ADDENDUM NO. CC-3

TELEGRAPH DISTRICT  
401 BUILDING RENOVATION  
LINCOLN, NEBRASKA  
DLR GROUP PROJECT NO. 10-16202-00

COMBINED CONTRACT

March 21, 2016

NOTE:  
THE CONTRACTOR SHALL BE RESPONSIBLE FOR SHORING, SHEATHING, OR OTHERWISE MAINTAINING THE SIDES OF THE EXCAVATION FROM CAVE-IN AND OTHER HAZARDS UNTIL ALL BACKFILL IS COMPLETED. BACKFILL AS PER SPECIFICATIONS.

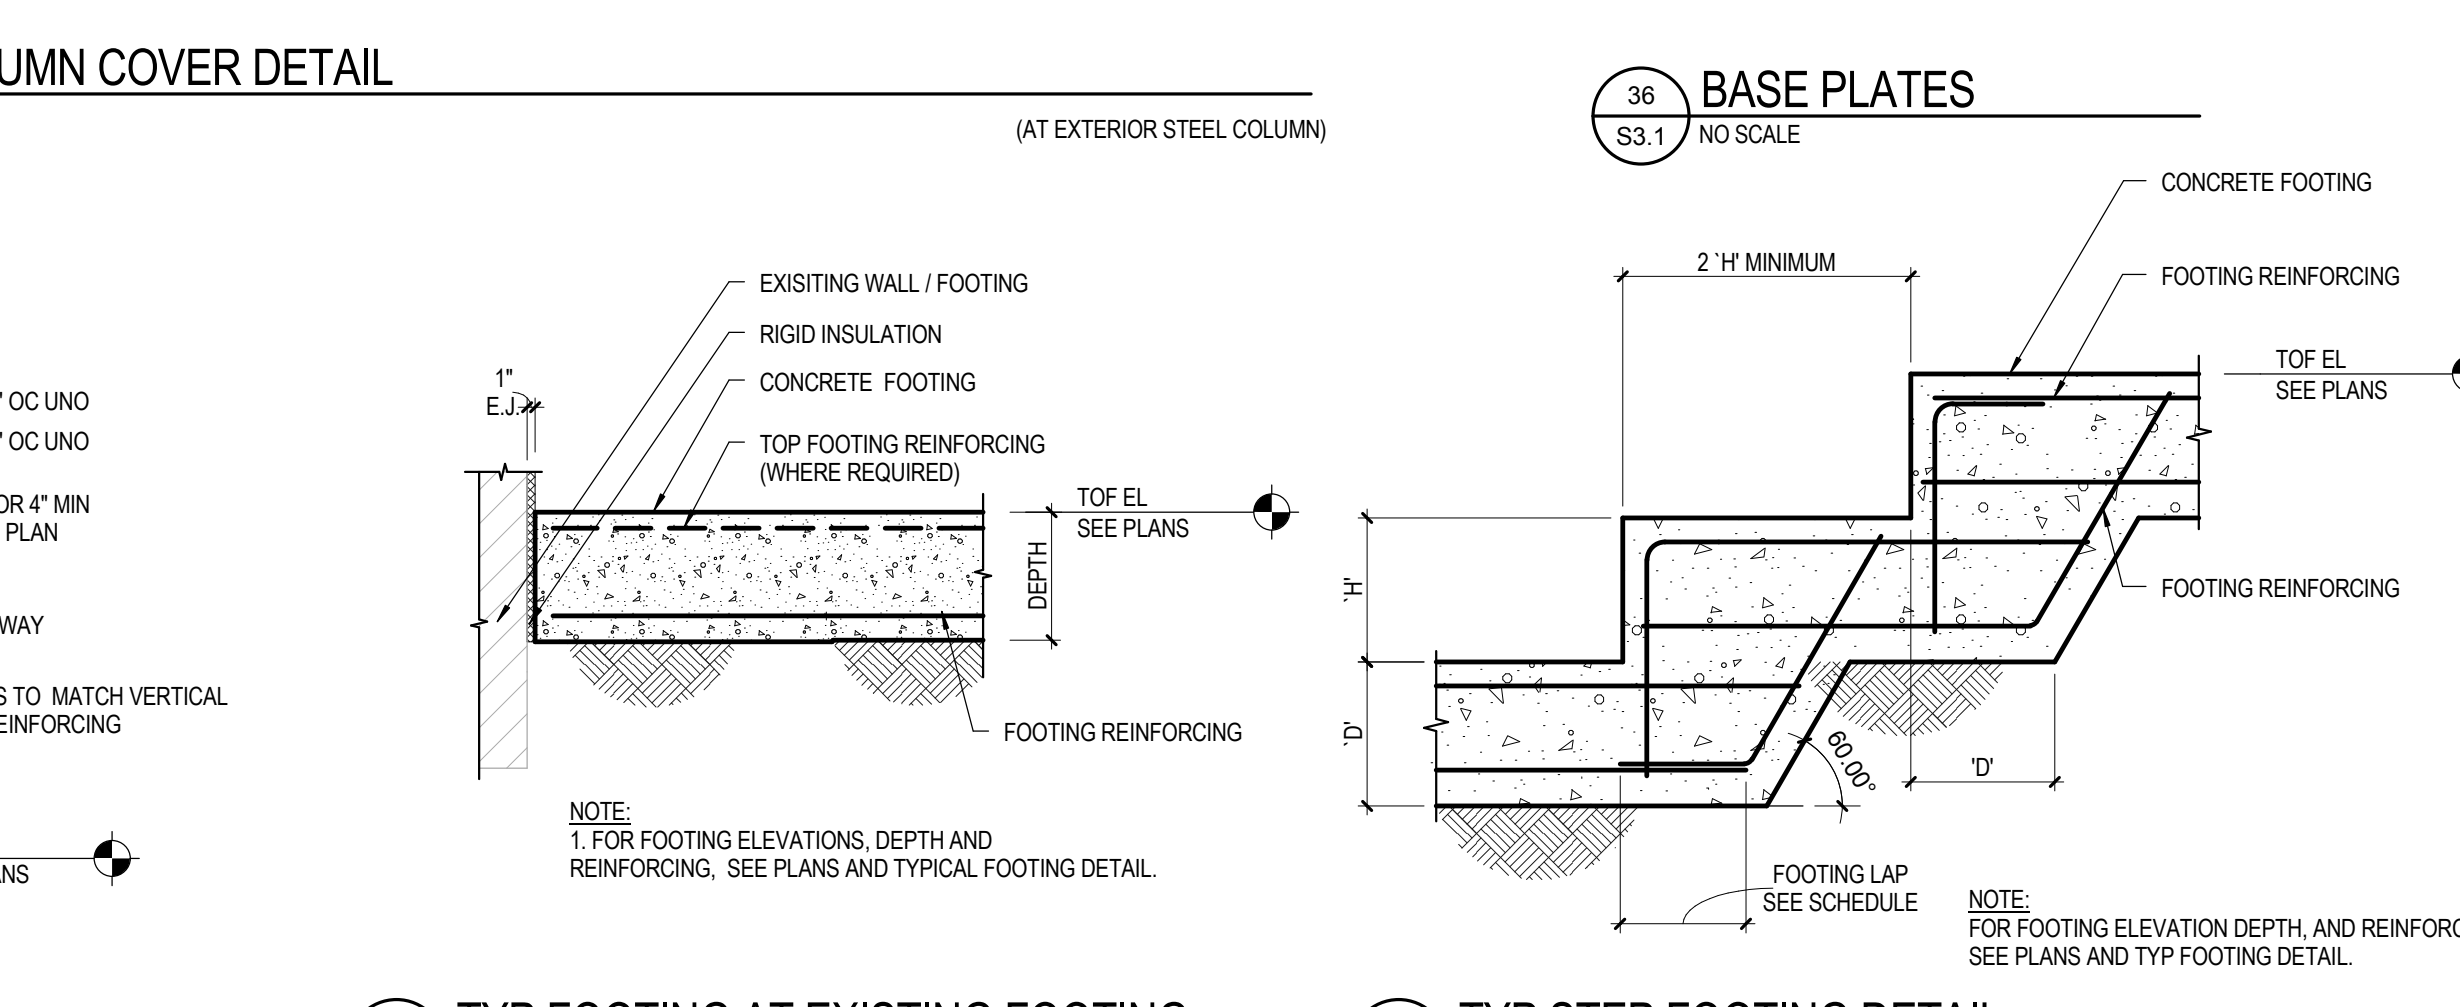
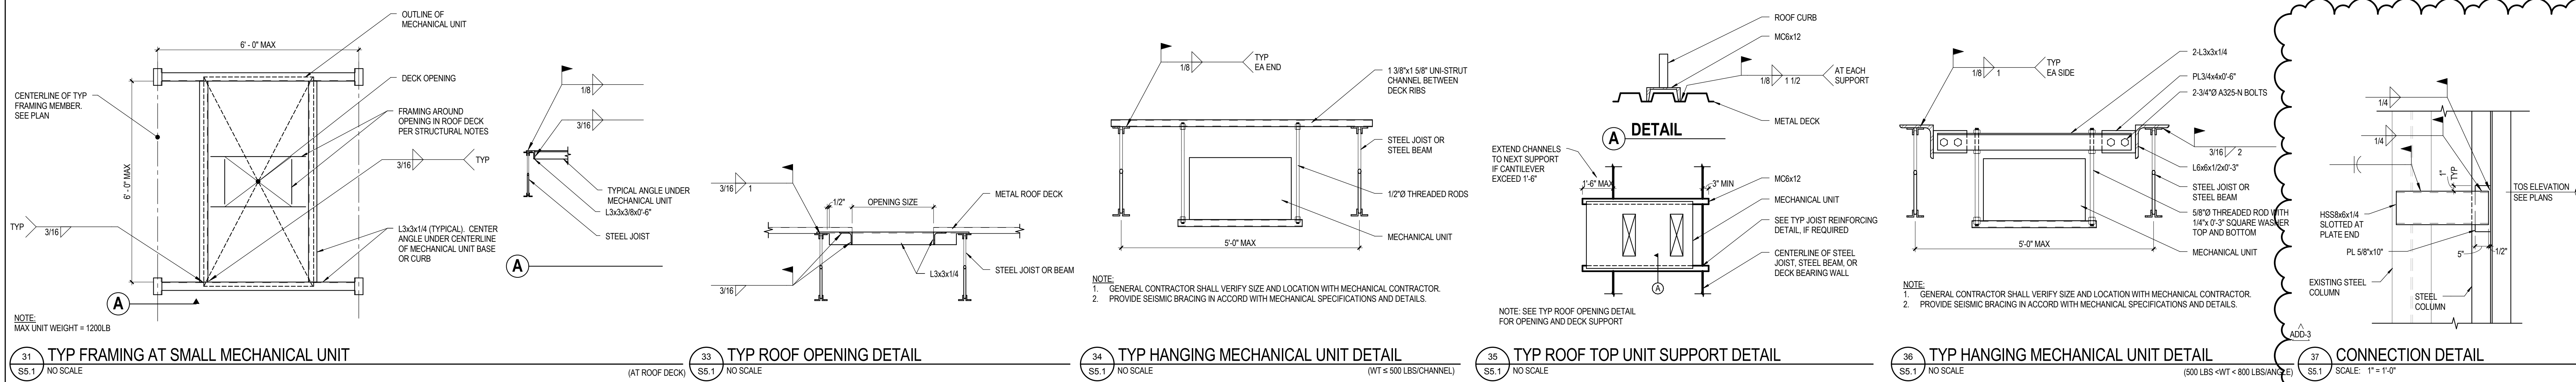
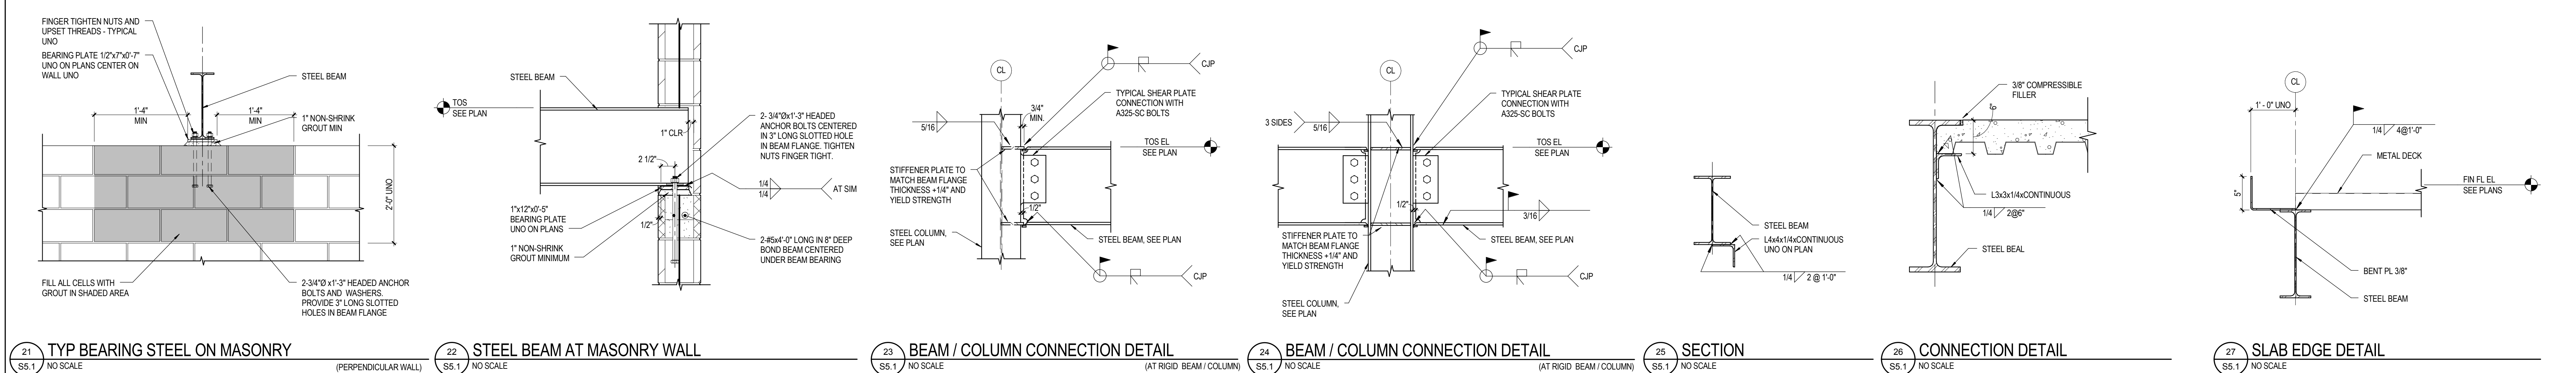
ITEM NO. 7 DRAWING S3.1 STRUCTURAL DETAILS

- A. Modify drawings as shown on Attachment S3.1-1
- B. Modify detail 35/S3.1 TYP COLUMN COVER DETAIL
- C. Add detail 36/S3.1 BASE PLATES
- D. Add detail 45/S3.1 TYP CONCRETE WALL FOOTING DETAIL
- E. Add detail 46/S3.1 TYP FOOTING AT EXISTING FOOTING
- F. Add detail 47/S3.1 TYP STEP FOOTING DETAIL

### PENTHOUSE HEAT RECOVERY UNIT DETAIL

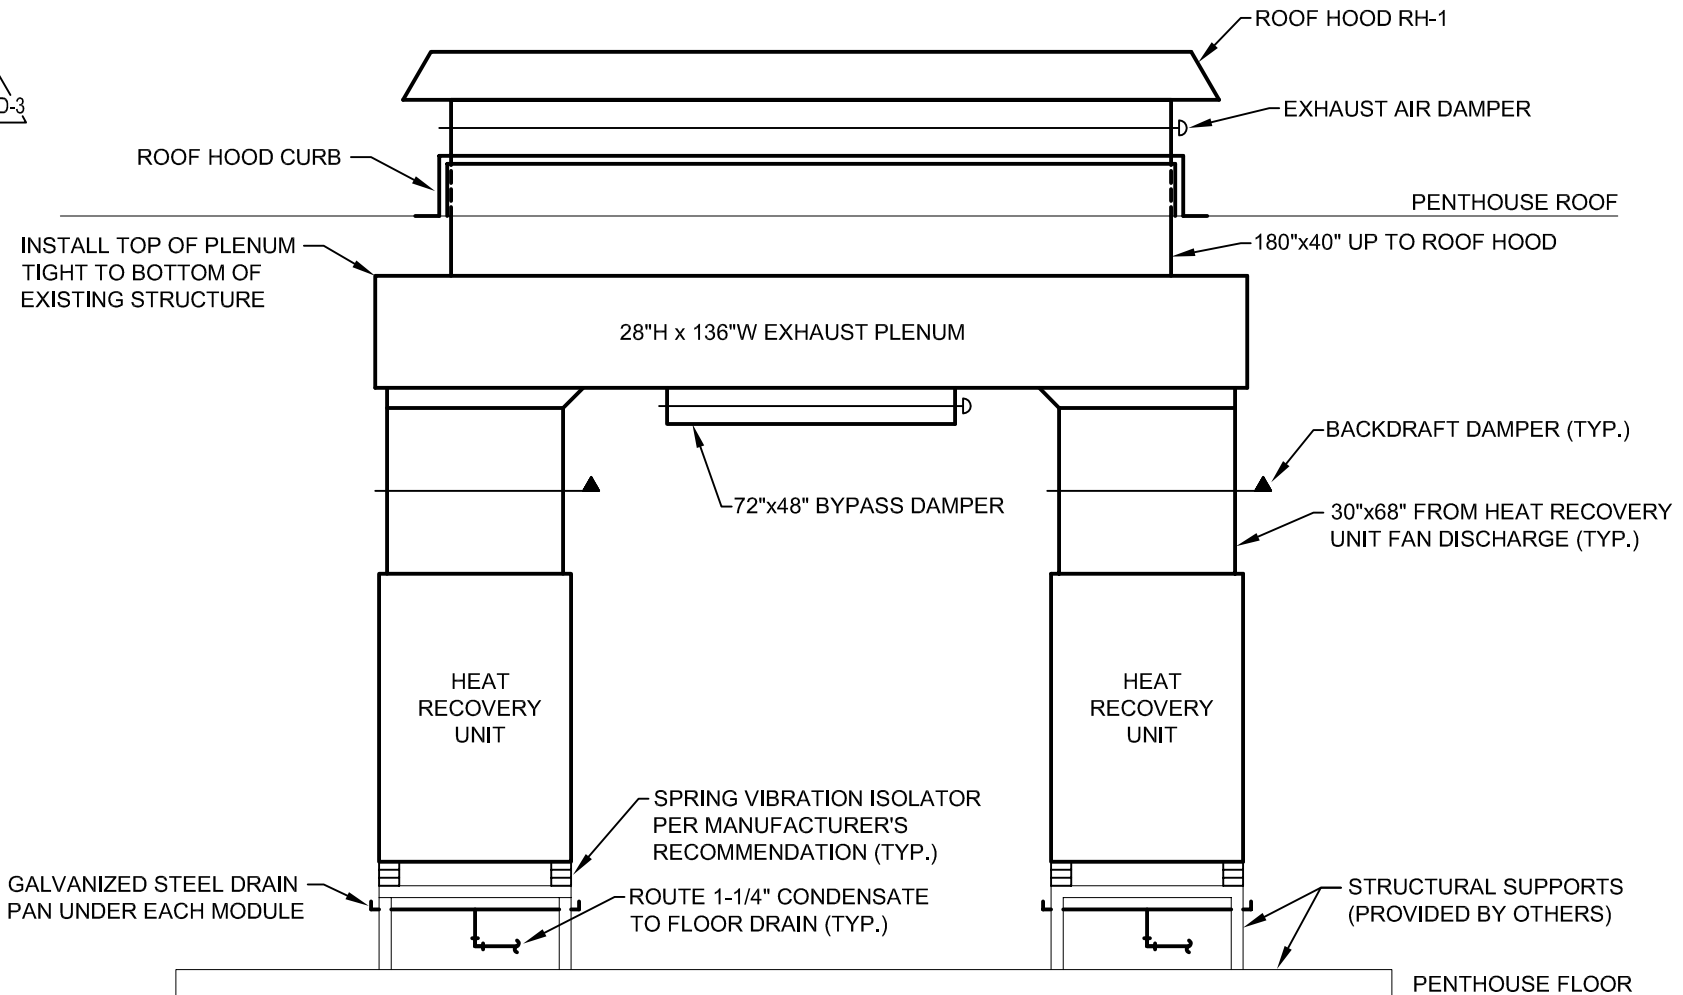
ITEM NO. 9 DRAWING M5.2 MECHANICAL DETAILS AND GAS RISER

- A. Add the Penthouse Heat Recovery Unit Detail as shown on Attachment M5.2.
